3.4 Water Level (Flood) Design

The information in this section of the reference ABWR DCD, including all subsections and tables and figures, is incorporated by reference with the following supplements and departures.

Figure 3.4-1 Non-Breaking Wave Force on Vertical Wall

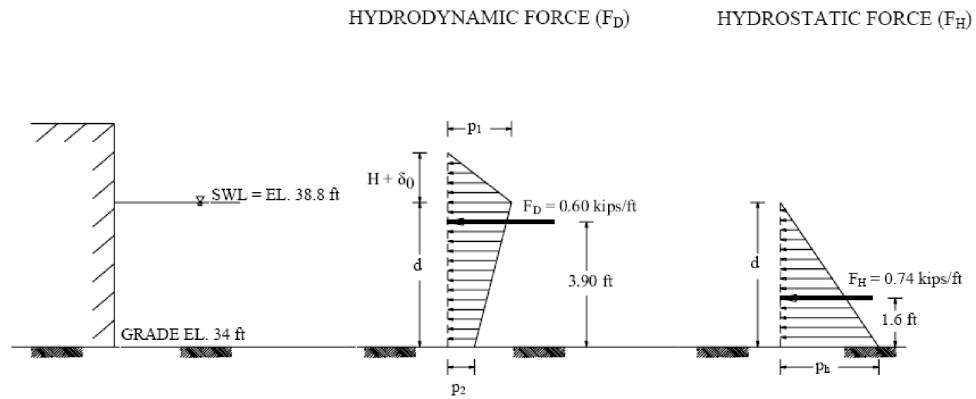
As discussed in Section 2.4S.4.2.2.4.3, the hydrodynamic force due to the wind-generated wave action on building walls has been calculated as shown in Figure 3.4-1.

- Wind generated wave forces as shown in Figure 3.4-1, applicable to above grade portion.
 - Impact due to a 500 lbs floating debris traveling at 4.72 ft/sec.

FL = Design basis extreme flood loads, including the hydrostatic load due to flood elevation at 40 ft MSL, the associated drag effects of 44 psf, impact due to floating debris per Section 3.4.2, and hydrodynamic load due to wind-generated wave action per Figure 3.4-1. Figure 3.4-1 shall only be used to calculate hydrodynamic load due to wind-generated wave action. The weight of the water (above ground) due to the flood loads shall be 63.85 pcf in order to include the effects of suspended sediments in the water.

- F_D = Resultant hydrodynamic force (in kips per linear foot) equivalent to the hydrodynamic wave pressure (p_1 and p_2) acting on the structure
- F_H = Resultant hydrostatic force (in kips per linear foot) equivalent to the hydrostatic pressure (p_b) acting on the structure
- H = Non-Breaking Wave Height(1%) = 2.1 ft
- T = Non-Breaking Wave Period = 1.7 sec
- d = depth of water at the structure = 4.8 ft
- δ_0 = vertical shift of the wave crest and trough at the structure = 1.0 ft
- p_1 = hydrodynamic wave pressure at the still water level = 132.8 lb/ft²
- p_2 = hydrodynamic wave pressure at the base of the structure = 32.5 lb/ft²
- p_b = hydrostatic pressure at the base of the structure = 306.5 lb/ft²
